Access Compliance Report

Public Rights-of-Way

(Curb Ramps)

Intersection ID: 45511	Main Street: MEADOW_BOTTOM_RD	Cross Street: GINHOUSE_LN	Location: S
ADA ID: 7BA93D74F15E	Ramp Type: PerpDiag	Initial Pass/Fail: Fail	Overall Compliance: No
Codes/Mitigation Info/Possible Solution		Field Measurements/Component Compliance

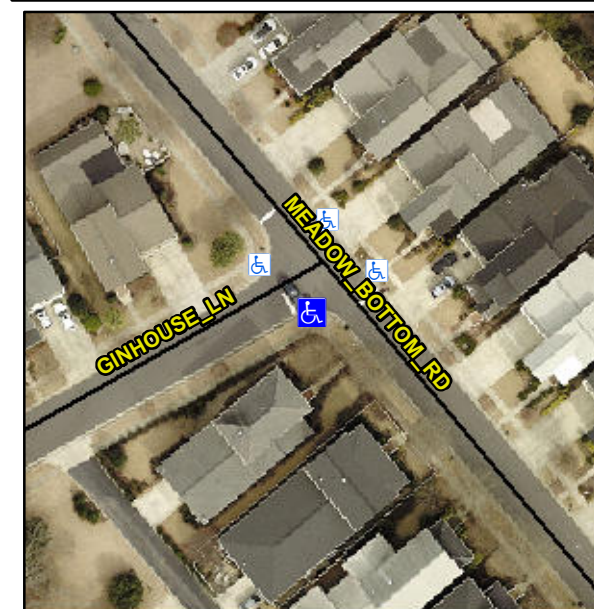
Not Found, R304.5.1, R304.2.2, R304.5.3

Compliance	Description	Data	Compliance	Description	Data
N/A	Ramp Length (in)	70.0	No	Ramp Slope (%)	11.1
No	Ramp Width (in)	31.0	No	Ramp XSlope (%)	2.1
N/A	Flare Type LT	N/A	N/A	Flare Type RT	N/A
N/A	Flare Slope LT (%)	N/A	N/A	Flare Slope RT (%)	N/A
N/A	Flare Traversable LT?	N/A	N/A	Flare Traversable RT?	N/A
N/A	Landing Length (in)	N/A	N/A	DWS Provided?	N/A
N/A	Landing Width (in)	N/A	N/A	DWS Contrast?	N/A
N/A	Landing Slope (%)	N/A	N/A	DWS Length (in)	N/A
N/A	Landing X Slope (%)	N/A	N/A	DWS Full Width?	N/A
N/A	Landing Curb? (Y/N)	N/A	N/A	DWS Offset (in)	N/A
N/A	Shared Landing?	N/A			
N/A	Gutter Ponding?	N/A	N/A	Gutter Slope (%)	N/A
N/A	Gutter Lip Ht (in)	N/A	N/A	Gutter X Slope (%)	N/A
N/A	Painted X Walk1?	No	N/A	Painted X Walk2?	No
	X Walk 1 Direction	To NE		X Walk 2 Direction	To NW
N/A	X Walk 1 Width (in)	N/A	N/A	X Walk 2 Width (in)	N/A
	X Walk 1 Slope (%)	1.9		X Walk 2 Slope (%)	3.0
	X Walk 1 X Slope (%)	2.4		X Walk 2 X Slope (%)	0.4

Remove & Replace Curb Ramp With Two New Directional Ramps or Equivalent.
